RE: Request for Permit Modification  
Municipal Solid Waste - Angelina County  
Angelina County Waste Management Center- MSW Permit No. 2105A  
CN600833511; RN101947323

In accordance with §305.70(l) and on behalf of Angelina County Waste Management Center, we hereby request a permit modification to the above referenced permit. The purpose of this permit modification is to revise the Site Development Plan (SDP), Attachment 12, Final Closure Plan to allow for an alternative final cover design over the Pre-Subtitle D areas to accommodate landfill gas header lines installed on top of intermediate cover.

**Part III - Site Development Plan  
Attachment 12 - Final Closure Plan**

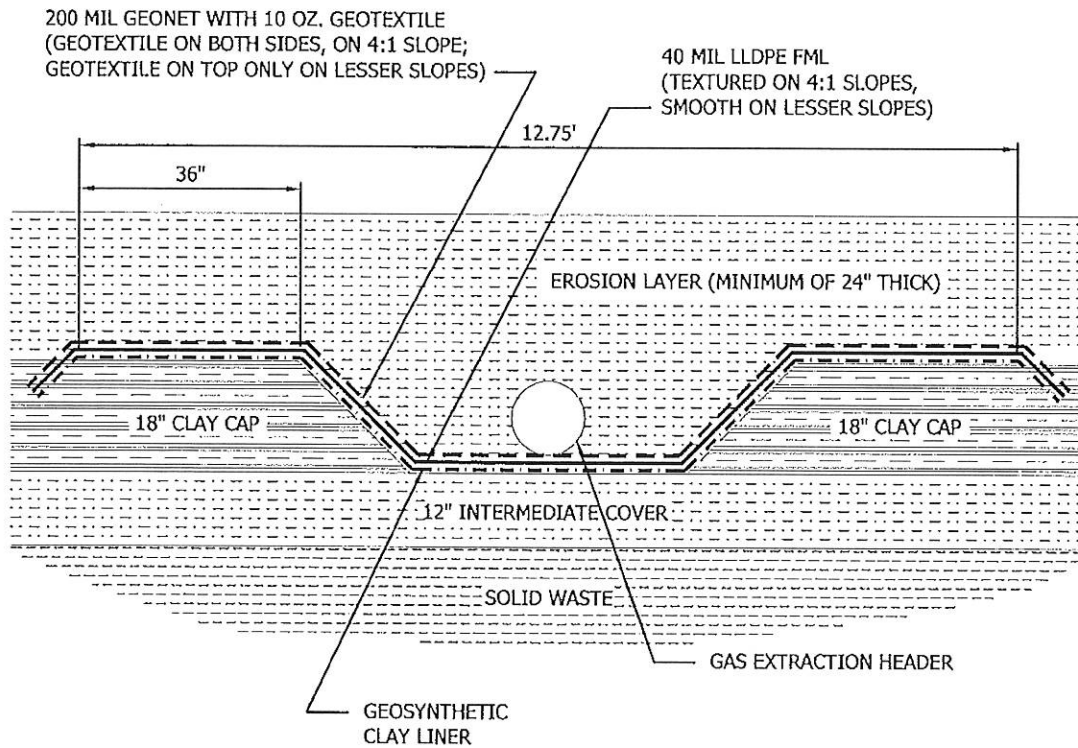
1. THIS DETAIL IS TO BE USED IN THE PRE-SUBTITLE D AREA WHERE GAS EXTRACTION HEADERS ARE ALREADY CONSTRUCTED AND LIE DIRECTLY ON INTERMEDIATE COVER.

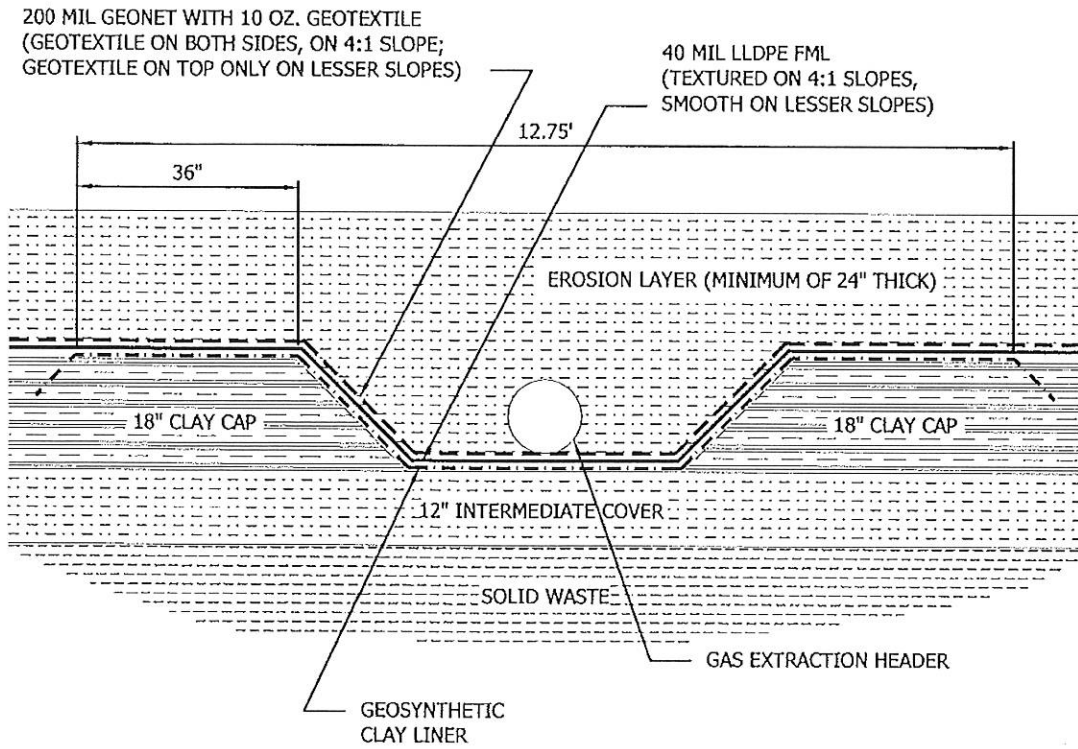
1. THIS DETAIL IS TO BE USED IN THE SUBTITLE D AREAS WHERE GAS EXTRACTION HEADERS ARE ALREADY CONSTRUCTED AND LIE DIRECTLY ON INTERMEDIATE COVER, AND WHERE THE ORIGINAL APPROVED SUBTITLE D FINAL COVER SYSTEM IS USED IN LIEU OF THE GCL.
2. THE ALTERNATIVE FINAL COVER SYSTEM (GCL, LLDPE AND GEONET) BEING UTILIZED WAS APPROVED FOR USE ON MARCH 18, 2011.
